Re: Vine Grove Elementary School  
Renovations 2011-2012  
Vine Grove, Kentucky

Change Order # 8

FIRST FLOOR HVAC PLAN - AREA "A"

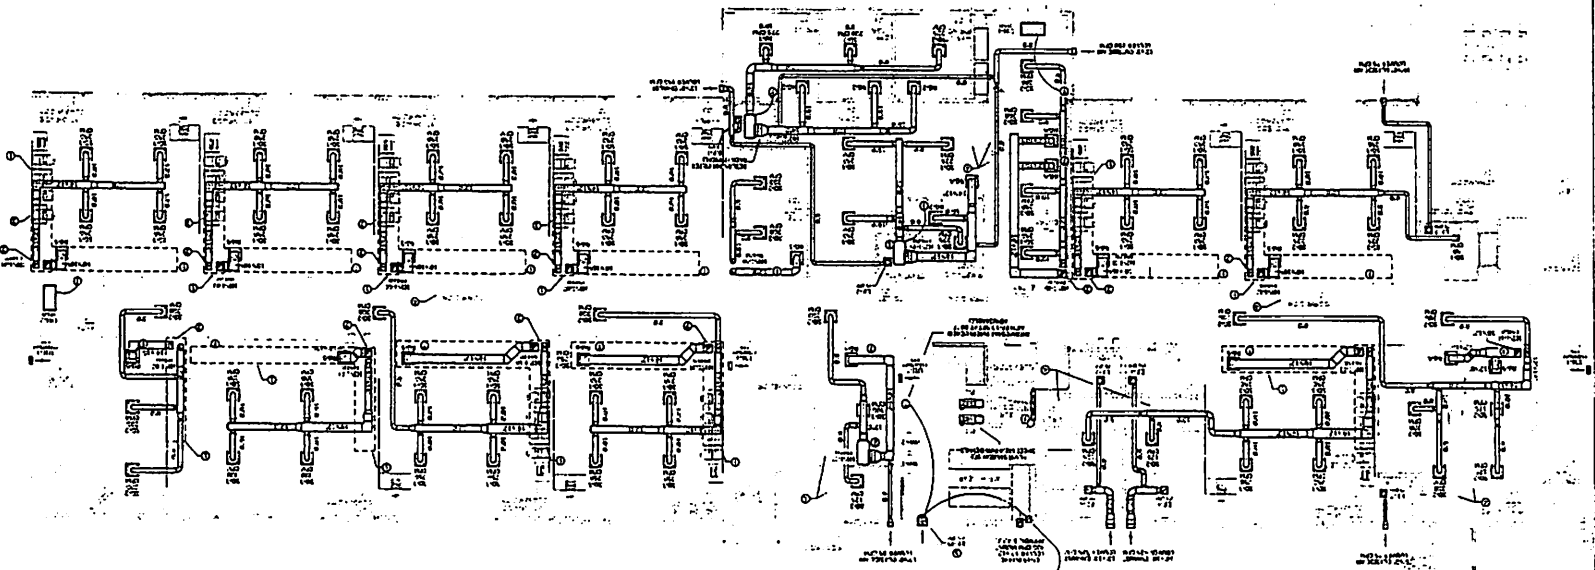
1. Contract documents originally called for removal of large amounts of plaster and lath to accommodate new ductwork and sprinkler lines above the first floor classroom ceilings.

2. Please do not remove any additional large areas of plaster from first level unless otherwise directed by myself.
3. It appears that all classrooms on the first level can be accommodated with either flattening out the supply ductwork as it crosses the existing sprinkler line closest to the corridor and/or having the ductwork go under the sprinkler line with the exception of Music Classroom 118 without having to remove the plaster and lath.

4. It appears, at this time, that the ceiling in Music Classroom 118 will require lowering.
5. Steve Wheatley stated he would look at flattening the ductwork per note 3 above.

6. If item 5 cannot be achieved in an acceptable manor we will create a drywall soffit as needed to cover the supply ductwork in those classrooms that will require it.

6. See attached pdf drawing from WBW regarding relocation of return air diffusers in Classrooms 110, 112, 113, 114, 118, 129 and 130. This drawing shows shortening return ductwork in these classrooms.

Since each classroom will have different conditions; credits for deleting plaster and lath, adds of supply ductwork modifications, credits for shorter return ductwork and credits for sprinkler piping not provided can be compiled at the end of first floor renovations.

<b>Vine Grove Elementary School</b>	<b>JOB NO.</b> 1014
 <b>PECK FLANNERY GREAM WARREN ARCHITECTS</b> 112 North Main Elizabethtown, Kentucky 42701	<b>DATE</b> FEB. 1, 2012
	<b>DRAWING</b> MOD. 35

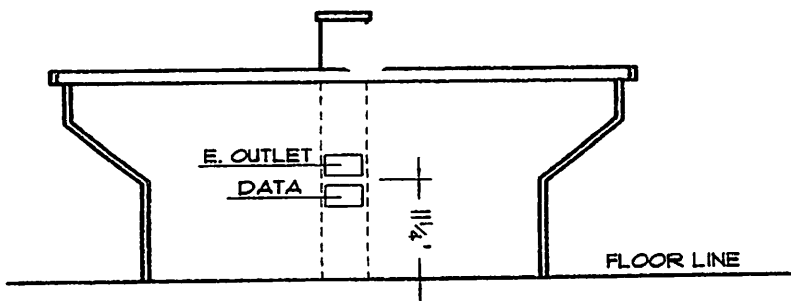
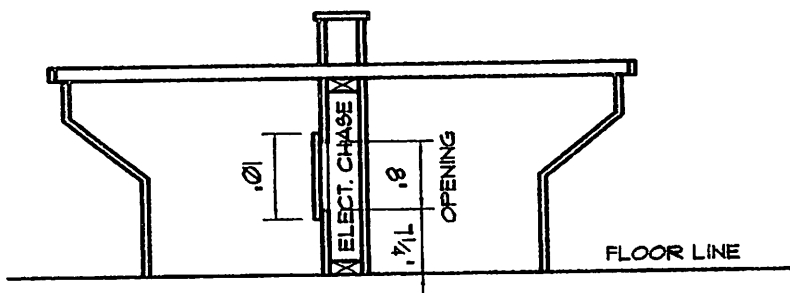
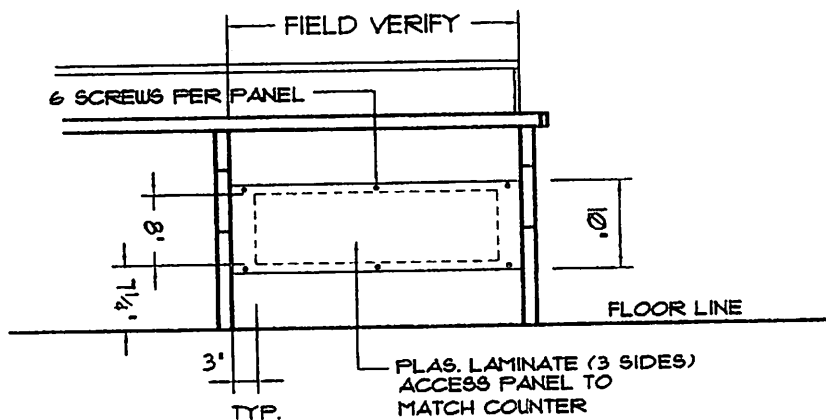
We reviewed the electrical requirements with Tim; per our instructions he is to provide 3 data and 1 electrical for the teacher work station along with all other controls and wiring related to the smart board. The receptacles are to be installed approximately half way from the bottom of the oak trim of the casework and the floor.

To provide this electricity and data an access panel will be required to be cut in the casework as shown on attached drawing. Please have Smith Laminating fabricate a plastic laminate cover panel with installation by McNutt Construction.

PLAS. LAMINATE (3 SIDES)  
ACCESS PANEL TO  
MATCH COUNTER

6 SCREWS PER  
PANEL

**PARTIAL FIRST FLOOR PLAN - AREA 'A'**

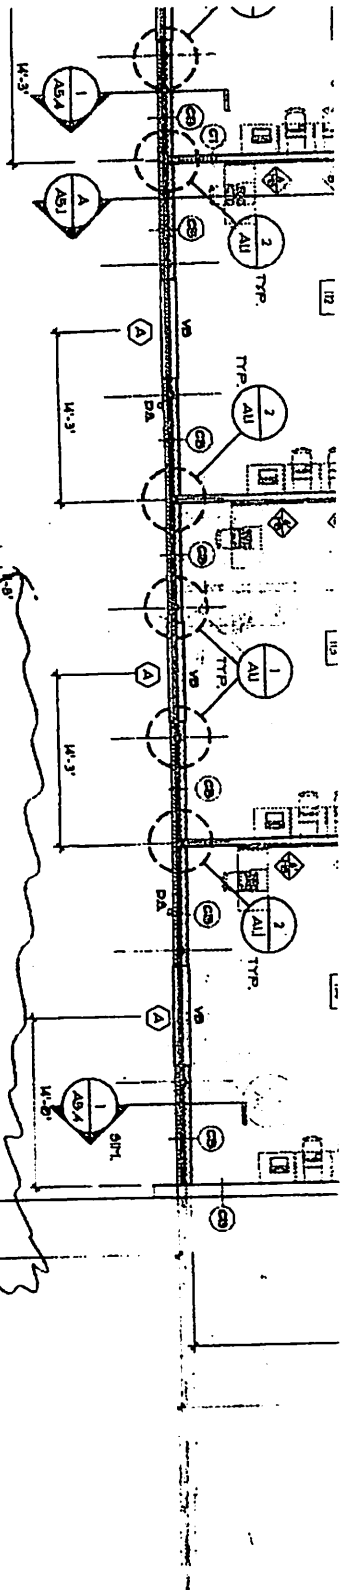
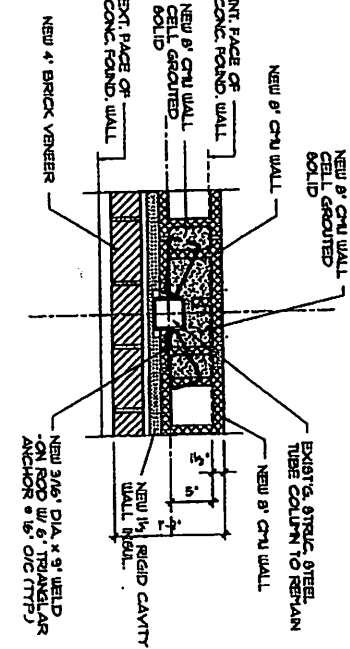
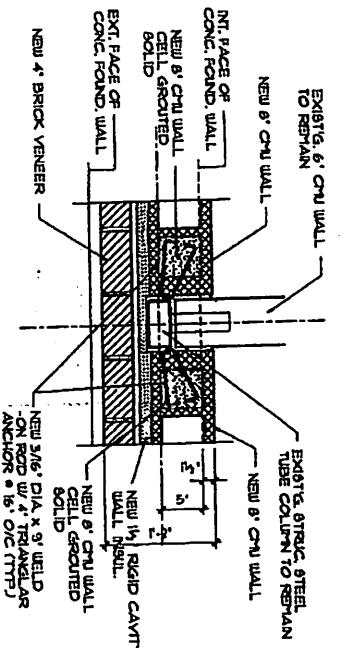
In addition to the previous credit requests for deletion of some site improvement items (attached), we would also like to request a credit for deleting the front canopy sidewalk extension that has not been installed as of this date (scanned drawing attached). If you have any questions concerning this request, please contact me at your convenience.
